Addendum 48 – Regulation No. 49

Revision 5 - Amendment 3

Supplement 6 to the 05 series of amendments – Date of entry into force: 10 June 2014

Uniform provisions concerning the measures to be taken against the emission of gaseous and particulate pollutants from compression-ignition engines and positive ignition engines for use in vehicles

"Figure 14

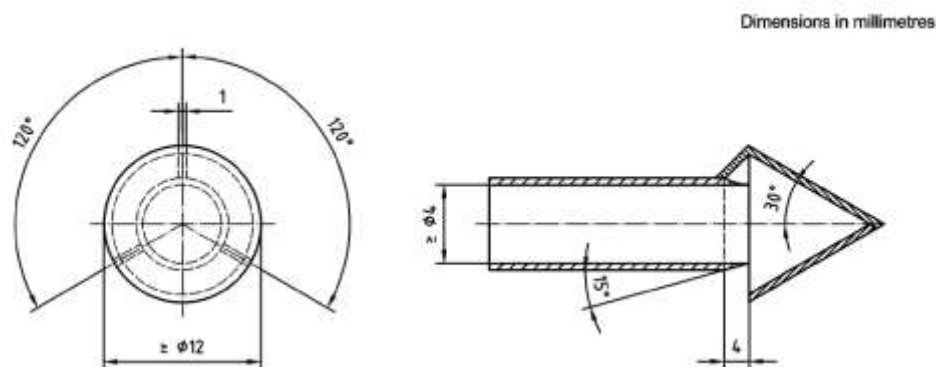
Figure 14, amend to read:
